Title: Permit #25-262: Lake Zumbra/Sunny Culvert Replacement, Victoria

Applicant: Three Rivers Park District

Recommendation:

Approval of MCWD permit 25-262 in accordance with the submitted plans, and on the following conditions:

LOCATION: CULVERT #1 - CAUSEWAY BETWEEN ZUMBRA AND SUNNY LAKES

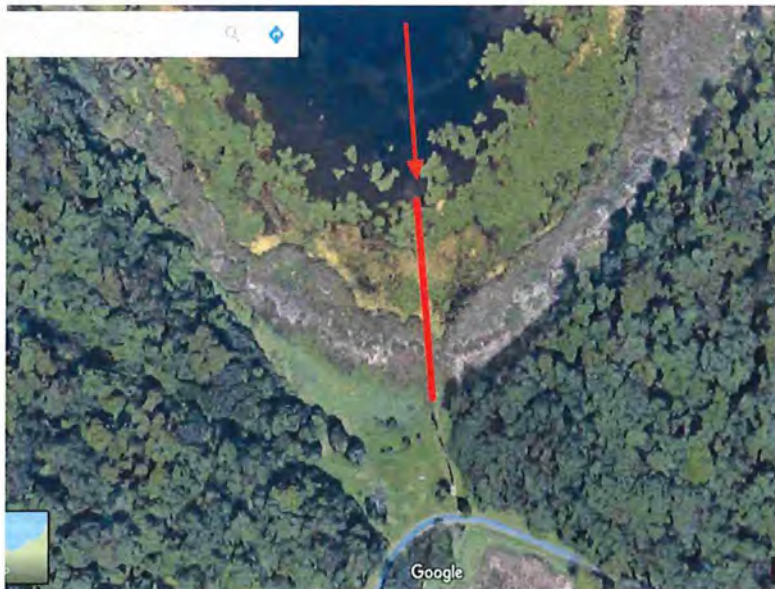
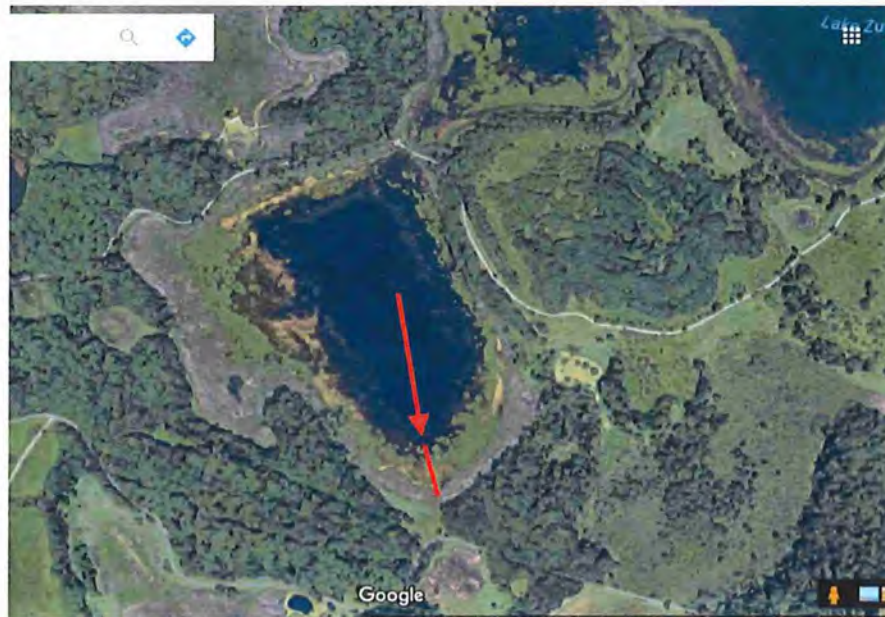
REQUEST: Remove debris fence to allow for unimpeded flow and migration of fish.

LOCATION: DRAINAGE DITCH - FROM CULVERT #2 TO UNNAMED WETLANDS

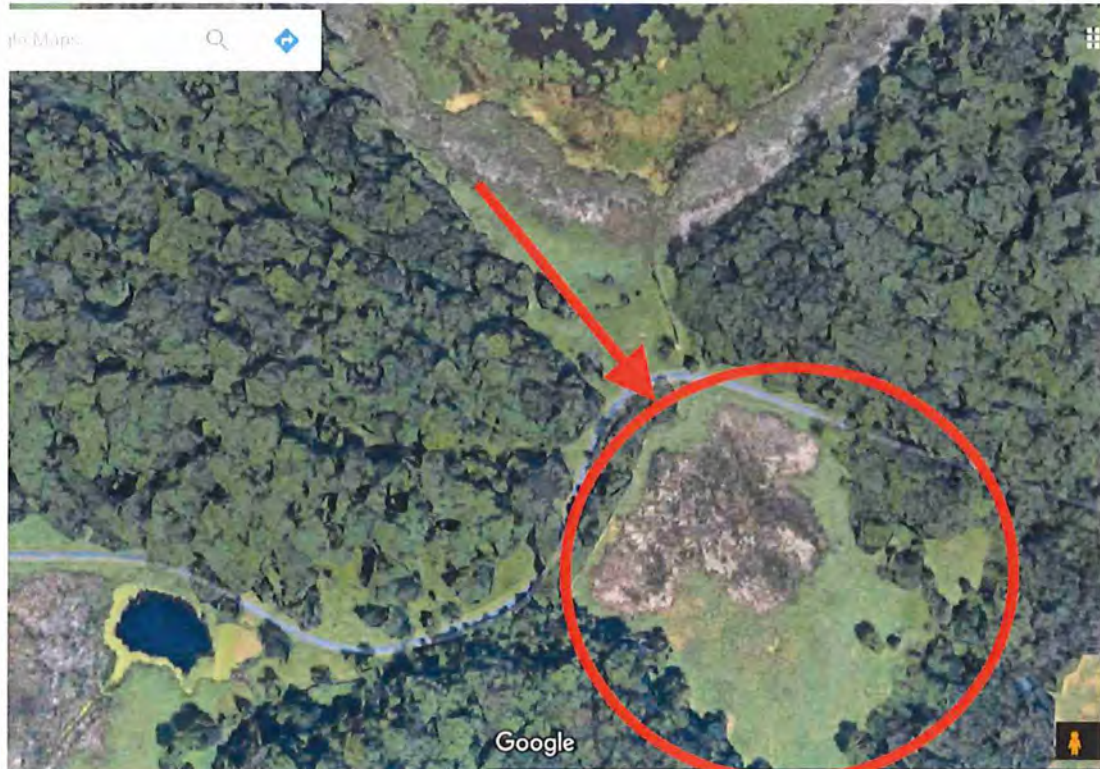
REQUEST: Clean out built-up sediment, bank erosion and debris from the ditch, to allow for a more unrestricted flow from Culvert #2 into the unnamed wetlands.

LOCATION: CULVERT #3 - CREEK AREA JUST EAST OF CULVERT #3 AT CO. RD. 11

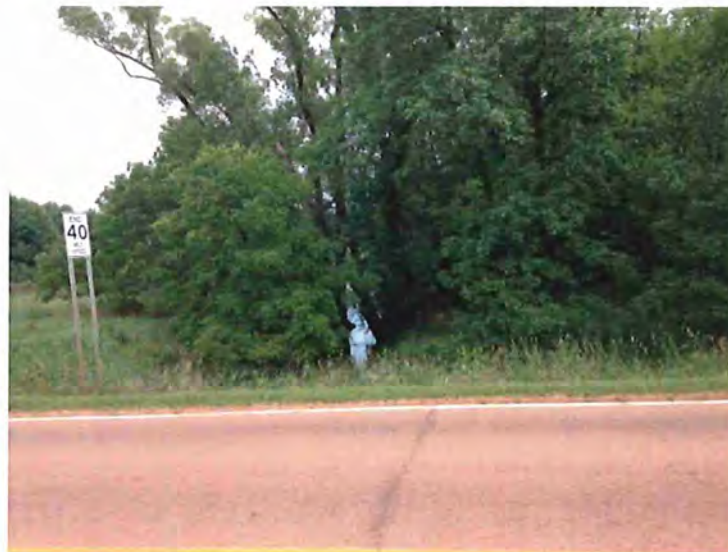
REQUEST: Remove source of constant debris that clogs the culvert. Remove trees and brush that exist between the culvert and the open wetlands area so water can flow unencumbered to and through Culvert #3. This will allow for proper and faster drainage of Sunny and Lake Zumbra.

LOCATION: FOUR SURVEY POINTS WITHIN THE SUBWATERSHED

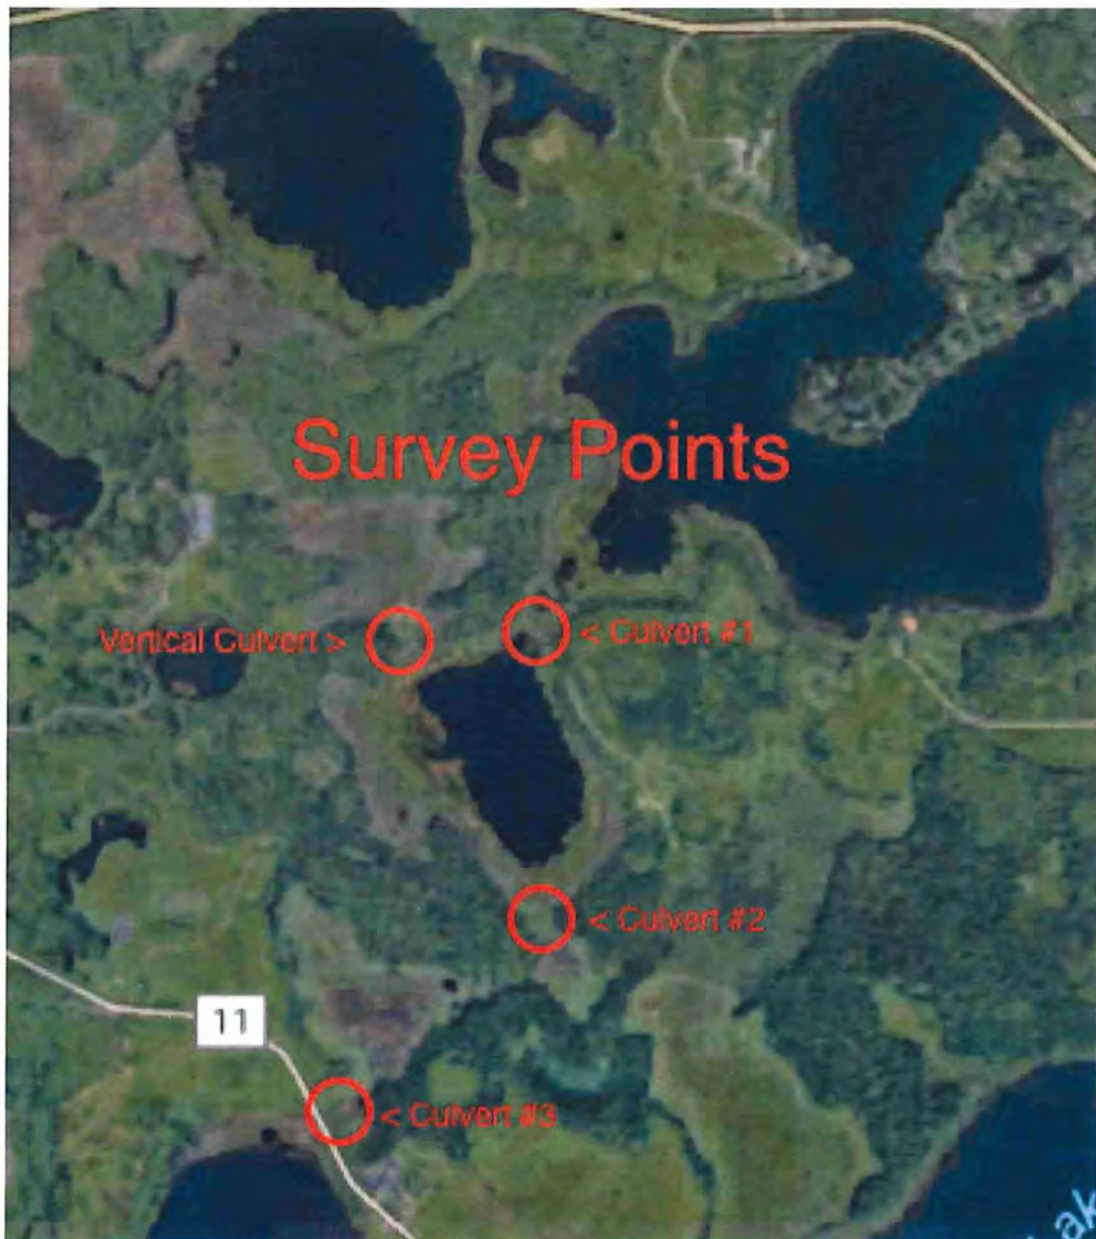
REQUEST: Provide permission to an independent surveyor to conduct a survey of the heights of four existing culverts for further study and data clarification. Survey company name, contact information, date of survey and duration on park property would be provided to Three Rivers Park staff prior to commencing survey.
